1926 Lake Shore Boulevard West - Zoning By-law Amendment Application - Request for Direction Report

| Reference Number: | 13 125924 WET 13 OZ |

The owner of the site at 1926 Lake Shore Boulevard West has appealed its Zoning By-law Amendment application to the Ontario Municipal Board (OMB) citing Council's failure to make a decision within the time required by the *Planning Act*. A Pre-Hearing Conference is scheduled for March 4, 2014, at which time a hearing date will be scheduled. The purpose of this report is to seek City Council's direction for the City Solicitor and appropriate City Staff to attend the OMB in opposition to the applicant's development proposal and appeal.

Attachment 3: Elevations

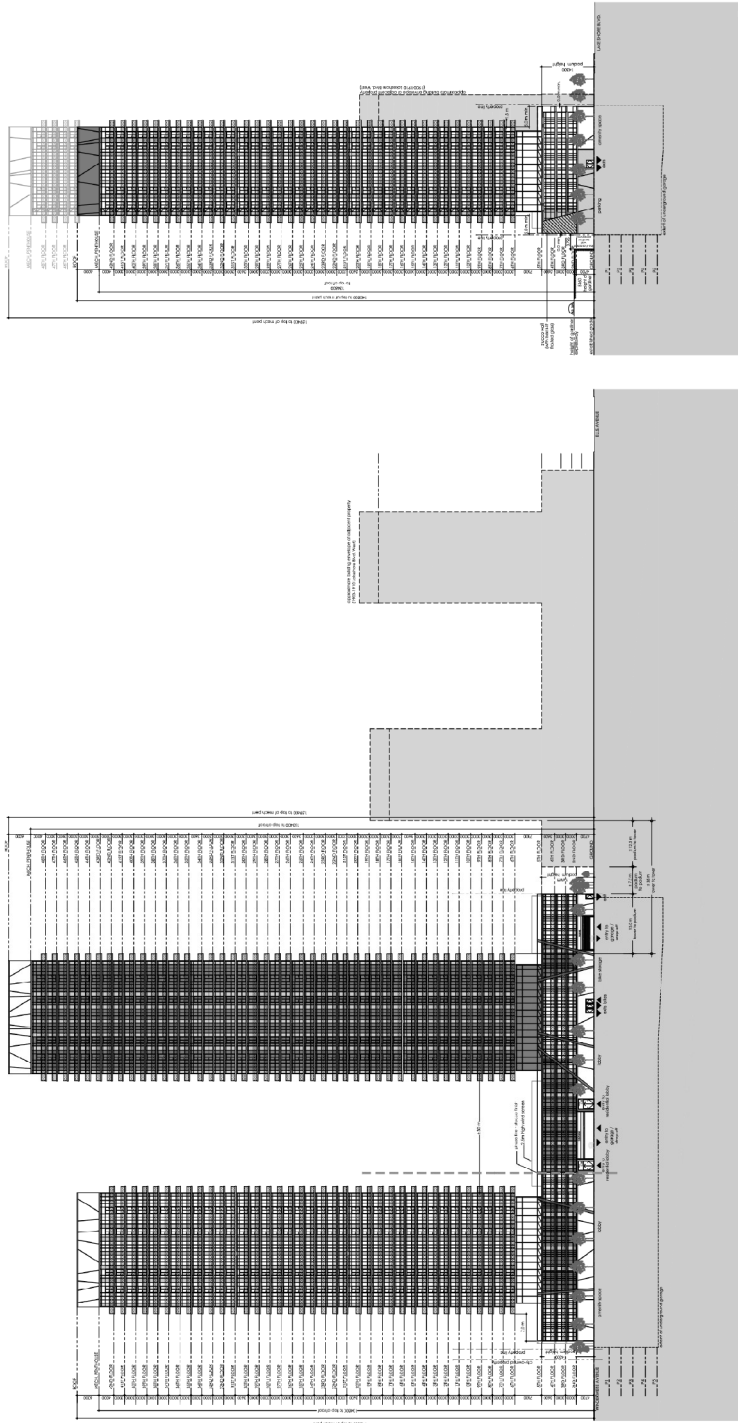
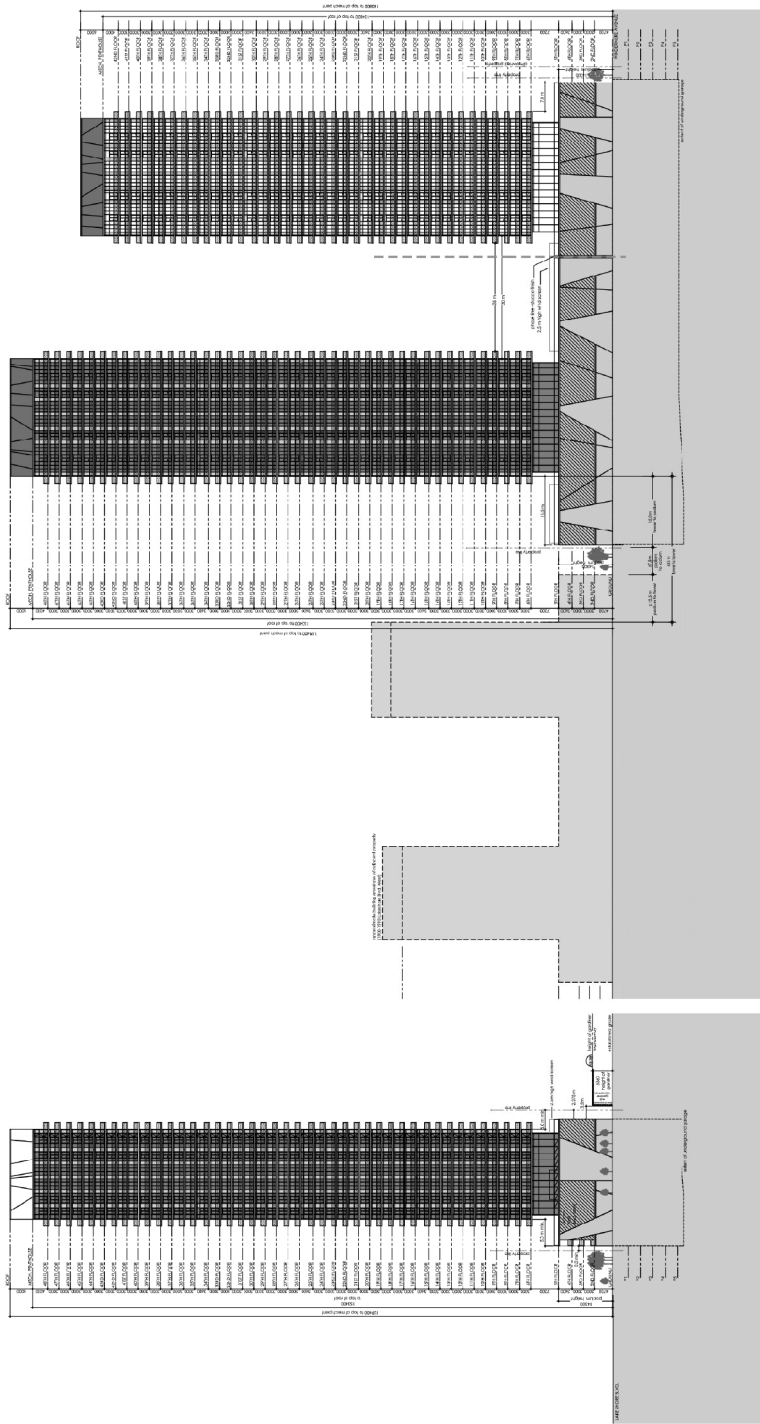
Staff have reviewed the proposed 42 and 48 storey buildings and are of the opinion the proposal lacks an appropriate transition in building height, scale and massing as required by the Official Plan and creates inappropriate shadowing impacts on surrounding lands. This proposal is not supportable in its current form.

The proposed two towers at 42 and 48 stories would not comply with the Tall Building guidelines or the Official Plan policies as they do not meet the criteria requiring the provision of an appropriate transition in scale between the proposed buildings and lower scale buildings and open spaces.
